Product Change Notification - SYST-11ALNE662

ERRATA - dsPIC33CH512MP508 Family Silicon Errata and Data Sheet Clarification

Description of Change: 1) Added silicon issue 21 (I2C).

dsPIC33CH512MP508 Family Silicon Errata and Data Sheet Clarification

FIGURE 1-1: I/O RAMP

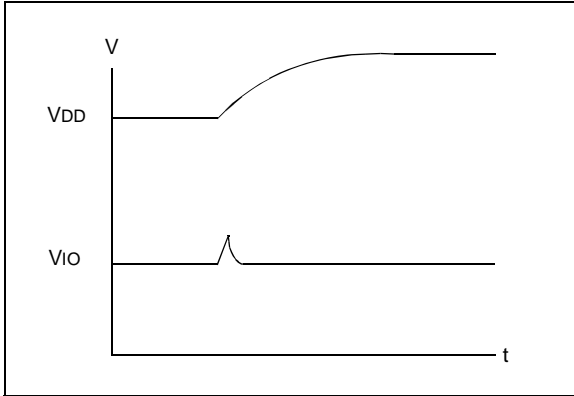
18. Module: I/O

During a fast device power-up, when the VDD ramp is less than 4 mS, the I/O pins may drive up to 100 μ A current for a duration of up to 10 μ S (Figure 1-1).

Work around

1. Slow down the VDD ramp time (greater than 4 mS for VDD to ramp 0V to 3.3V).
2. Ensure the circuitry that is connected to the pins can endure this pulse.

Example applications affected may include complementary power switches, where a transient current shoot-through might occur. High-voltage applications with complementary switches should power the high-voltage 200 μ Sec later than powering the dsPIC[®] device to avoid the current shoot-through. This behavior is specific to each device and not affected by aging.
